Location:	2100 Telegraph Avenue (See map on reverse)
Assessor's Parcel Numbers:	008-0648-001-00; -011-03; -016-03; -017-00 & -018-00
Proposal:	Design Review discussion for two potential final development plans for the entirety of the Eastline Project Planned Unit Development. The different development plans are as follows: Scheme A – Proposal would include a mixed-use development with approximately 80,000 square feet of ground floor retail, approximately 18,000 square feet of community and/or assembly space, approximately 880,000 square feet of office in a building that is broken into three masses varying in height from 180 feet to 240 feet, and 395 dwelling units within a high-rise tower of approximately 440 feet in height at the corner of Broadway and 22nd Street. Scheme B – Proposal would include a mixed-use development with approximately 69,000 square feet of ground floor retail, approximately 22,000 square feet of community and/or assembly space, and approximately 1,500,000 square feet of office use. The building would include building massing for most of the site with a height of approximately 215 feet and a large office tower along the Broadway frontage that would be 29 stor

TELEGRAPH PLAZA COMPARISON

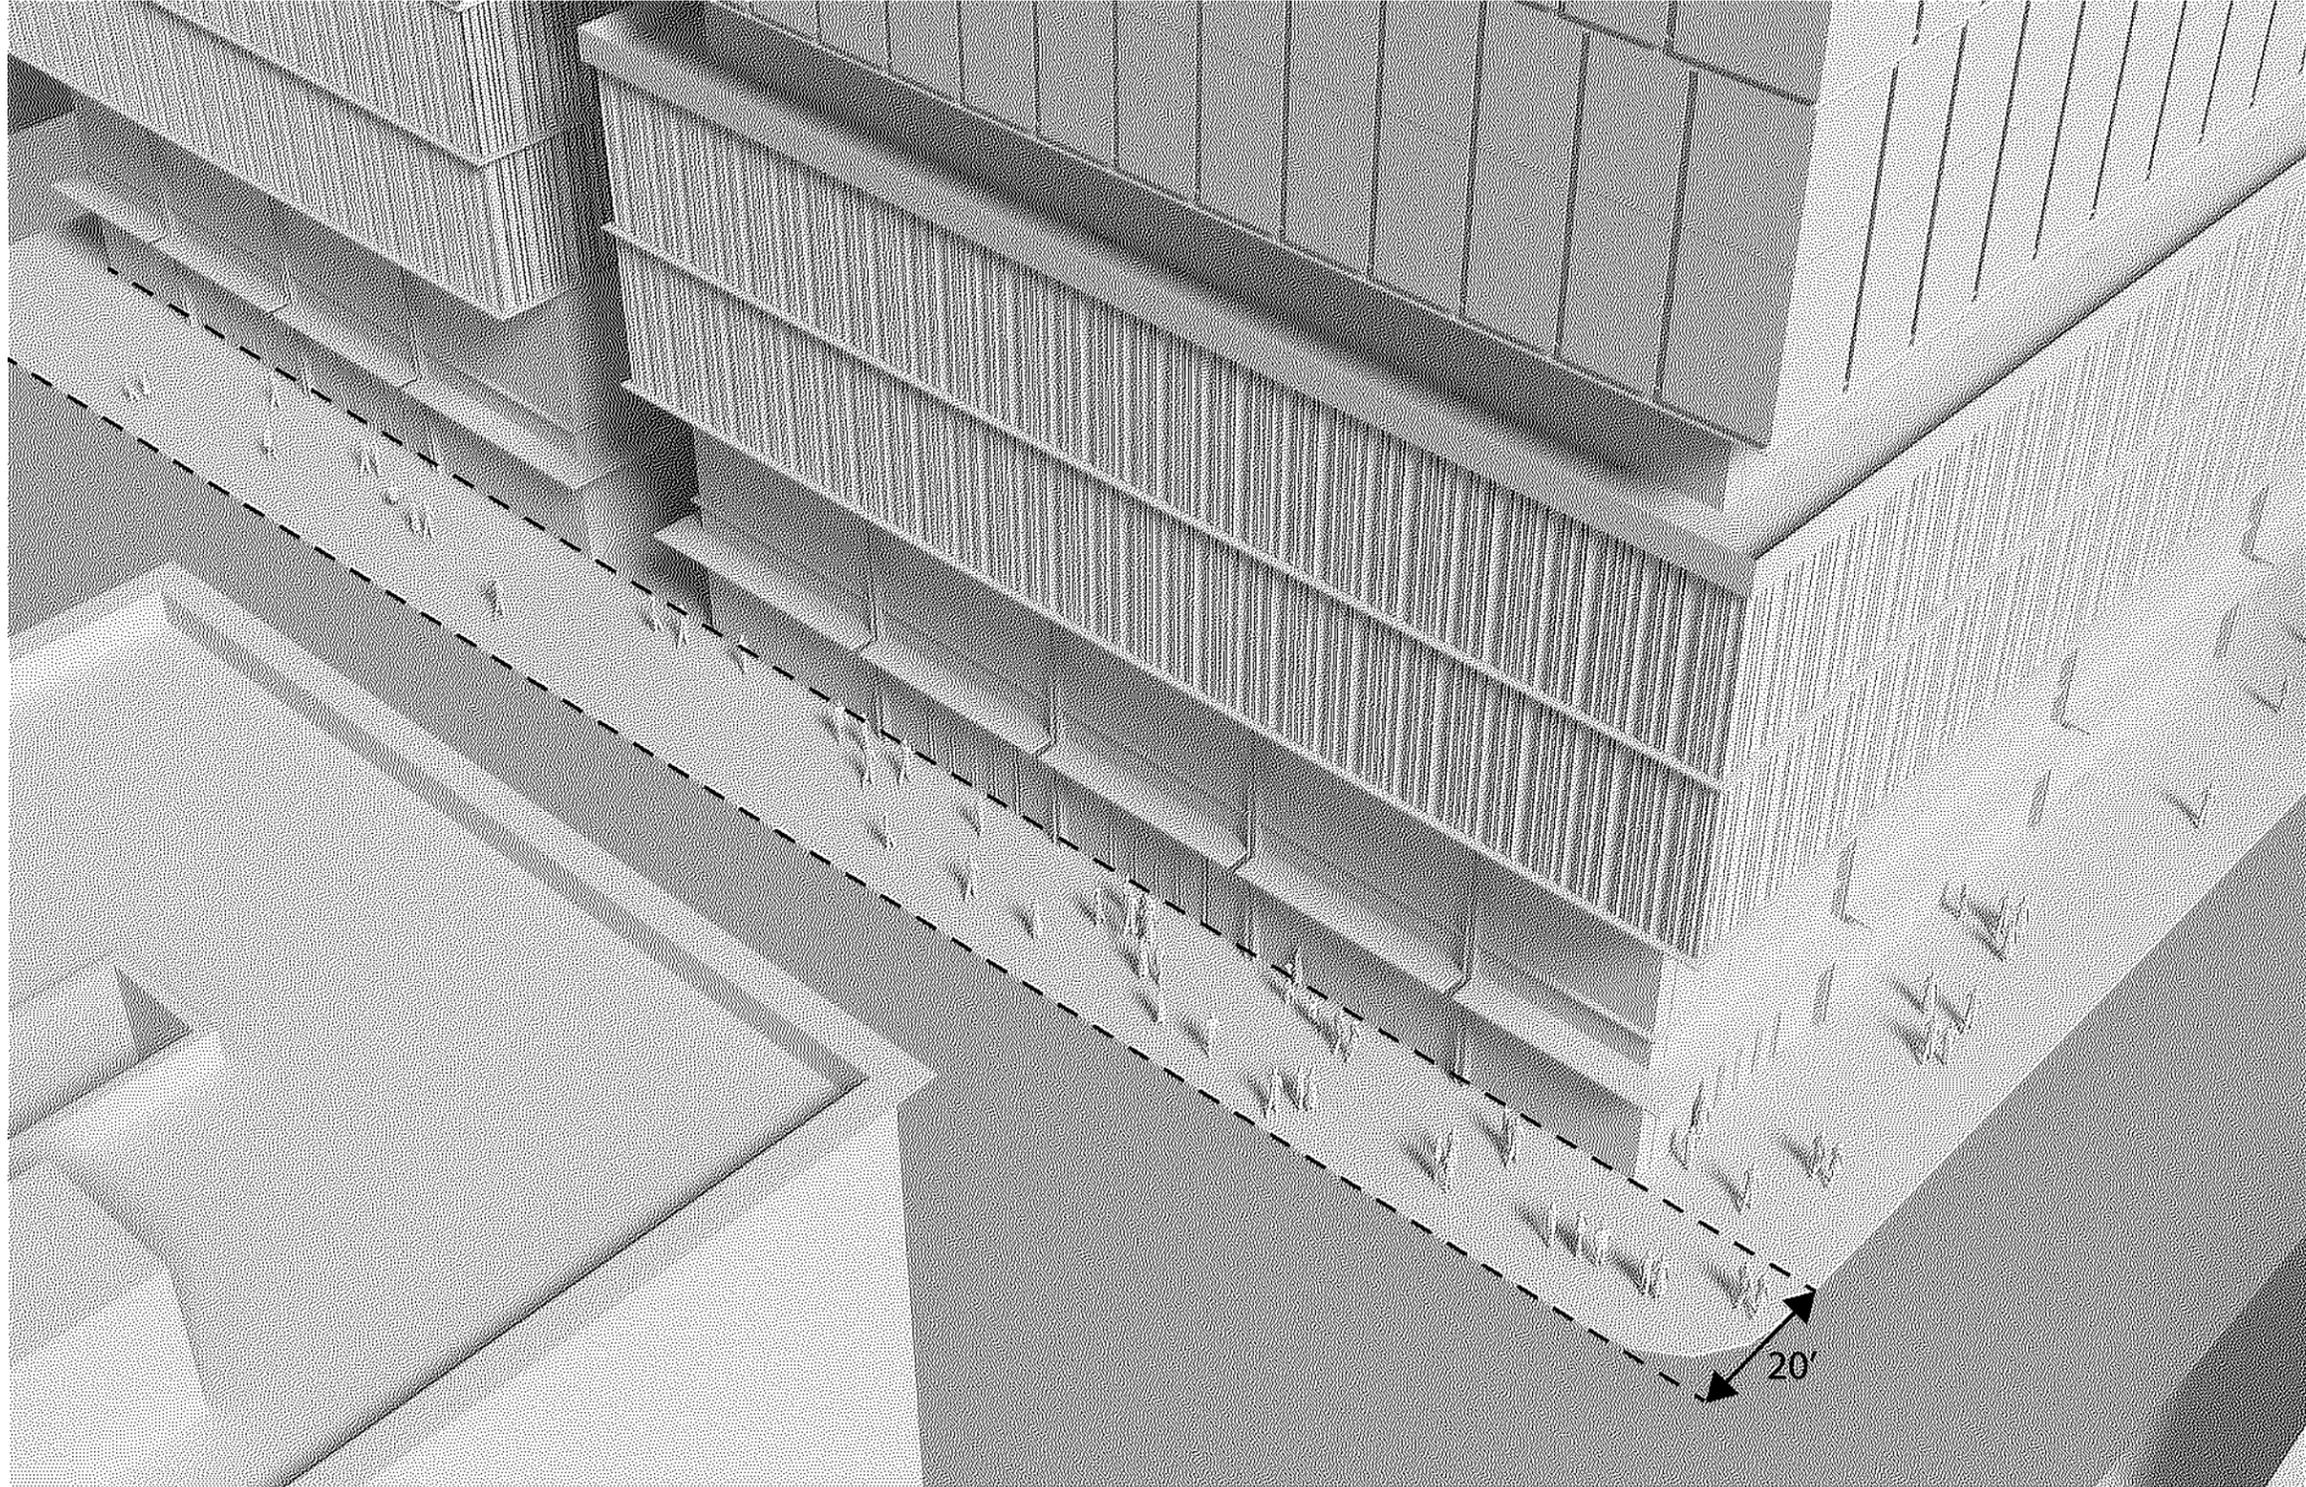
- Plaza on Telegraph – The concern was that the recessed plaza on Telegraph of 38 feet plus the 15-foot sidewalk may create dead space. The applicant has provided more detail into the design of the plaza and how it would be spatially separated by the sidewalk with raised landscaping areas and activated with adjacent retail uses, specifically restaurant uses.

CURRENT TELEGRAPH PLAZA DESIGN

PODIUM FACADE ANALYTIQUE COMPARISON

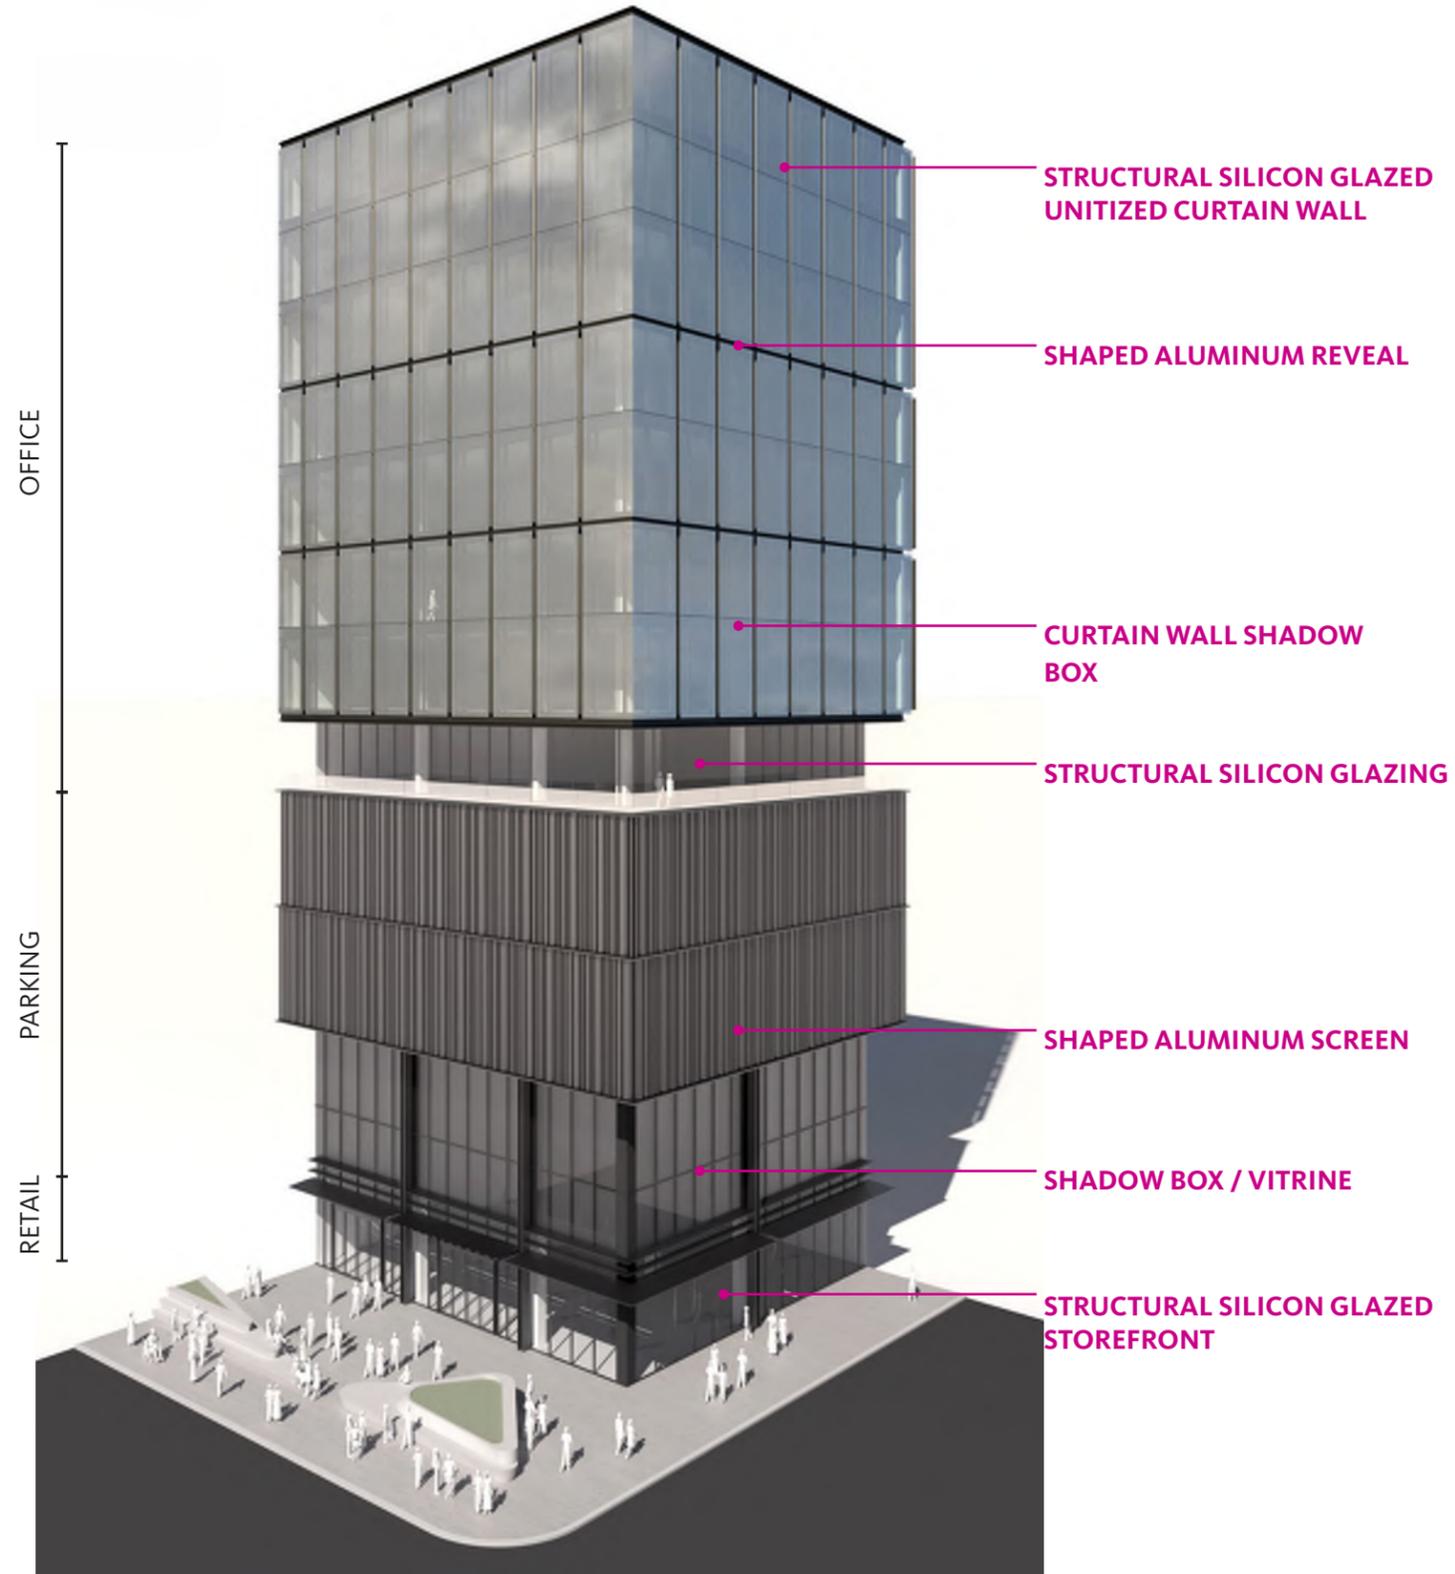
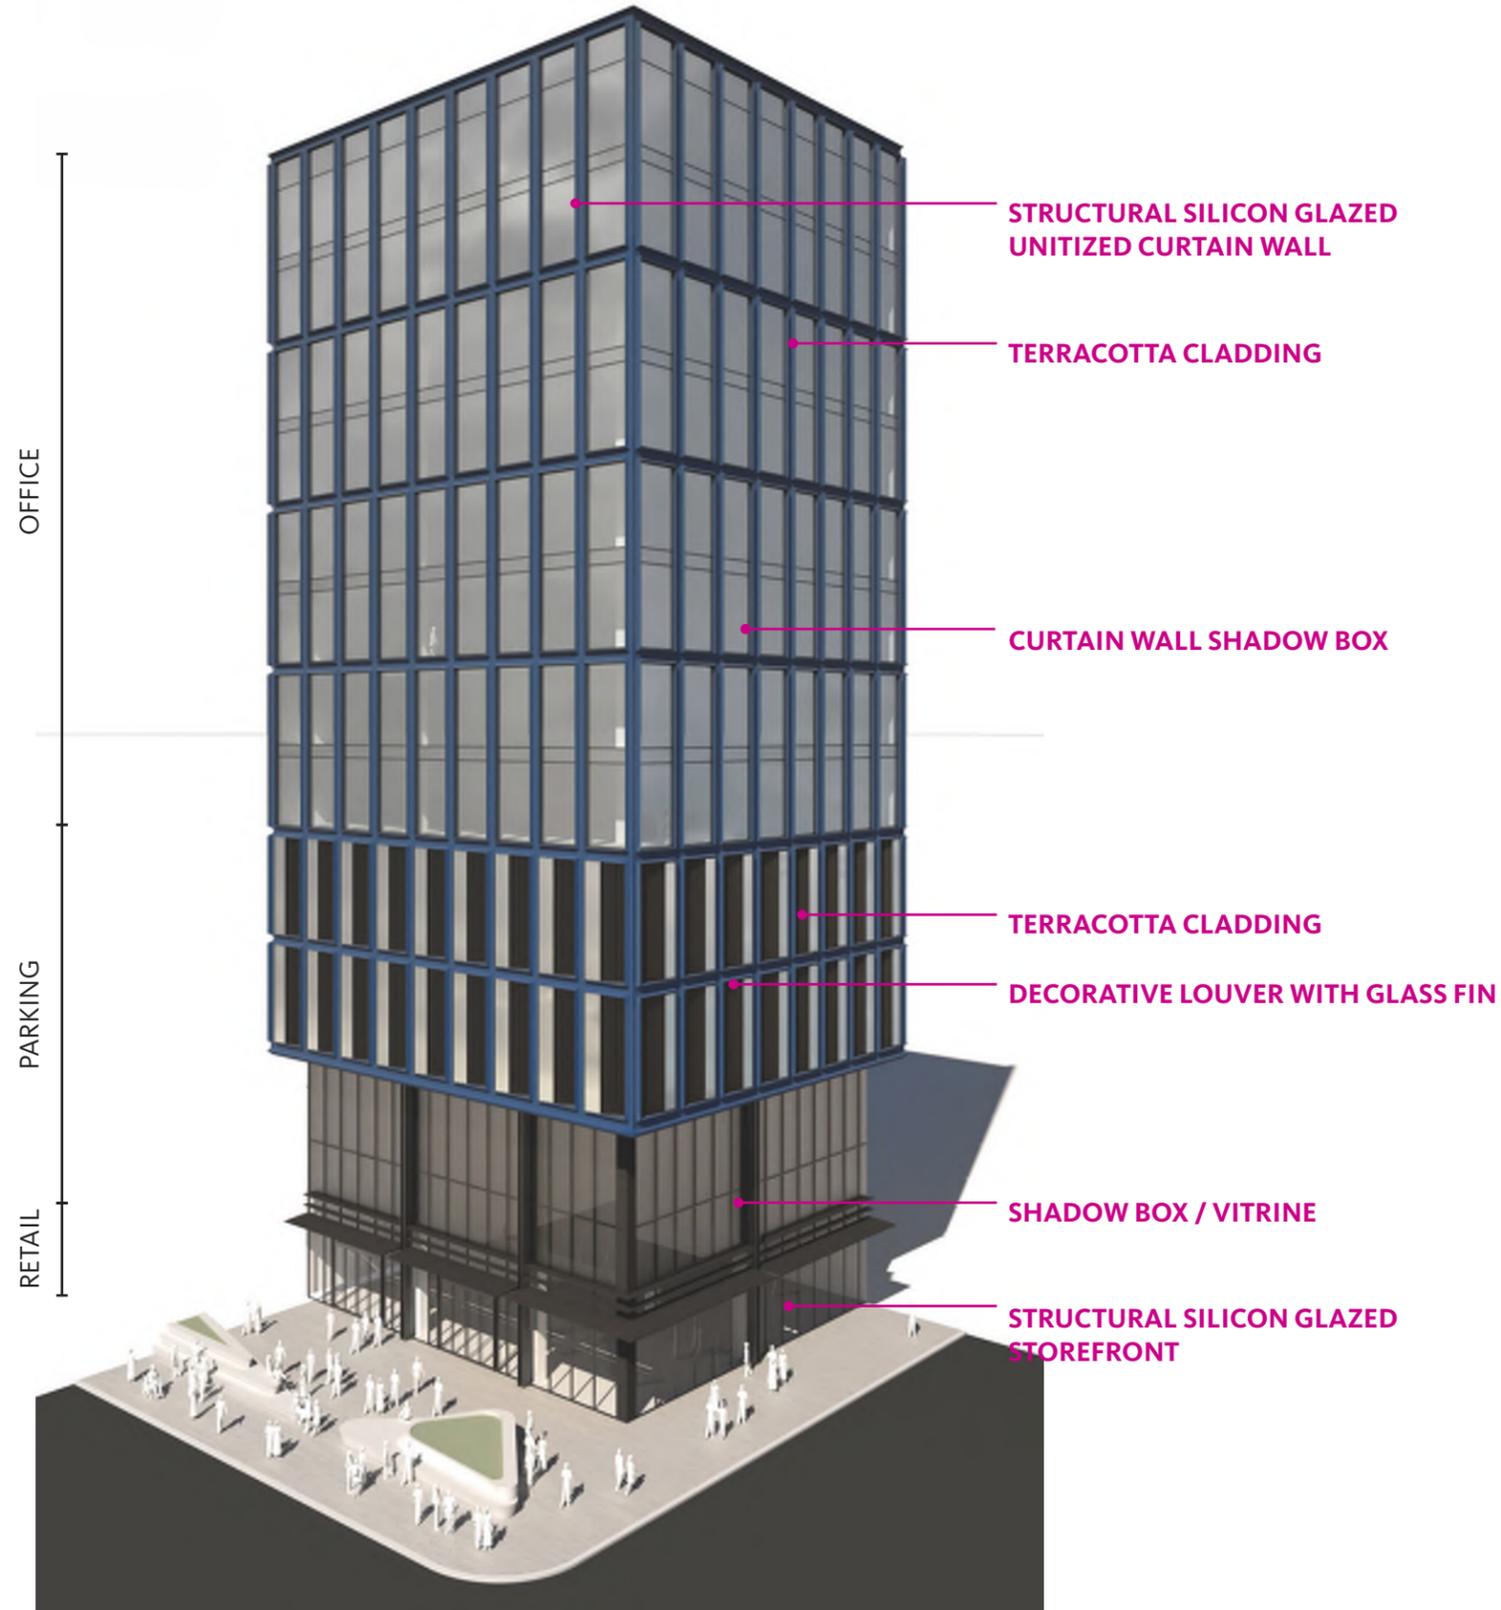
- Façade materials – It was recommended that the applicant look to include other materials to help break down the large glass facades of the buildings as well as provide a contextual relationship with some of the surrounding buildings that contain a mix of terra cotta and masonry exteriors. The applicant has included the use of a terra cotta material to break down the curtain wall system on the western portion of the project.

REVISED PODIUM FACADE ANALYTIQUE
